TO: DEVELOPMENT REVIEW BOARD **DATE:** 4/20/00
FROM: PROJECT COORDINATION
SUBJECT: CASE 39-DR-00

REQUEST: Approve 43,000 SF office buildings with site improvements
PROJECT NAME: Mountain View Office Condo
LOCATION: SEC 91st Street & Mountain View

STAFF RECOMMENDATION: APPROVE subject to the attached stipulations.

FULL CANTILVEVER CARPORT

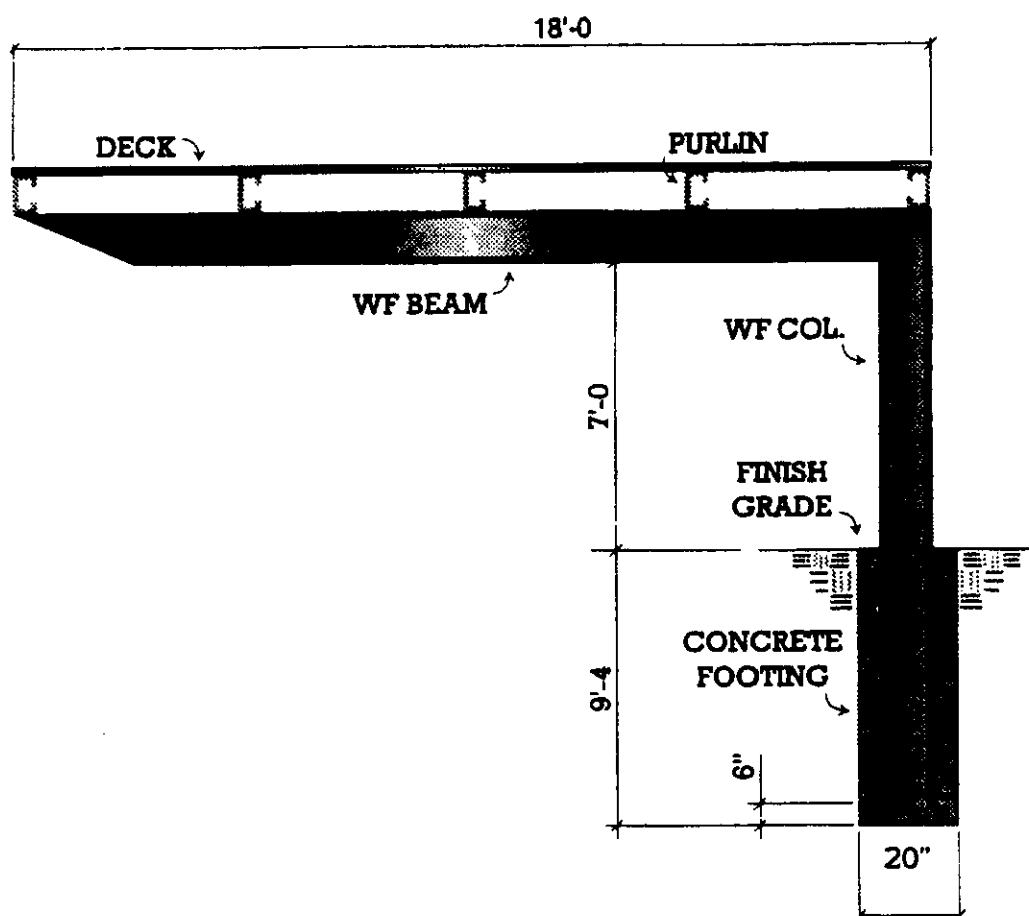
5. Carport design to be compatible with the building in use of colors, texture and detailing.
6. Carport roofing to be of a prefinished non-reflective material. No exposed galvanized metal allowed. Provide a minimum 4-inch fascia to cover edge of roof decking.
7. Show location and elevation of carports including fascias on all elevations and type of lighting.

DEAD-END PARKING AISLE DETAIL

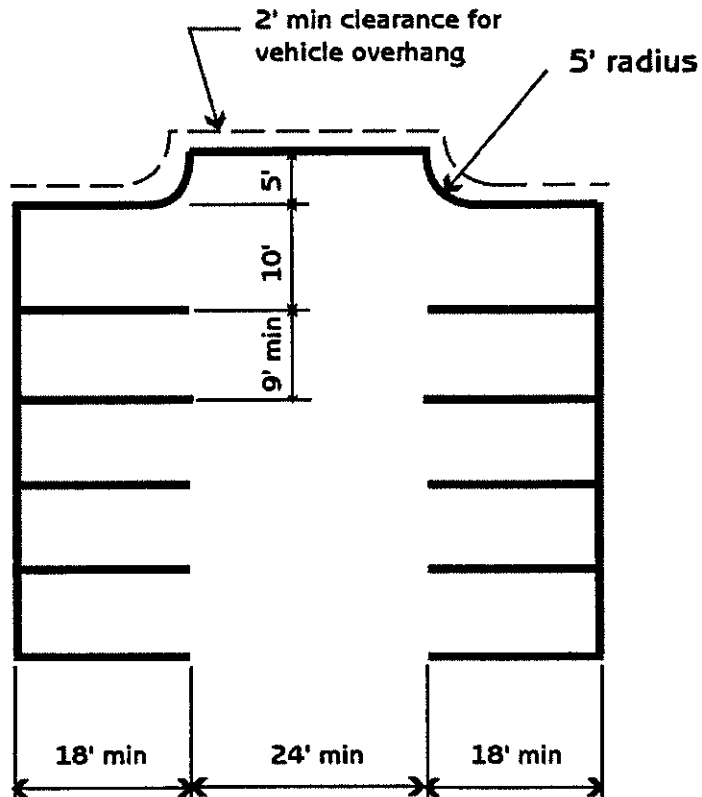
1. *The minimum internal parking aisle width shall be 24 feet.*
2. *The internal circulation shall be designed to accommodate emergency and service vehicles with a minimum outside radius of 45 feet and inside radius of 25 feet.*
3. *The dead-end parking aisles shall be designed in conformance with the attached detail.*

1. Maximum dead-end parking aisle length is 150 feet.
2. If the length exceeds 150 feet, a turn-around shall be provided for emergency vehicles.
3. No refuse enclosures are permitted on a dead-end aisle.
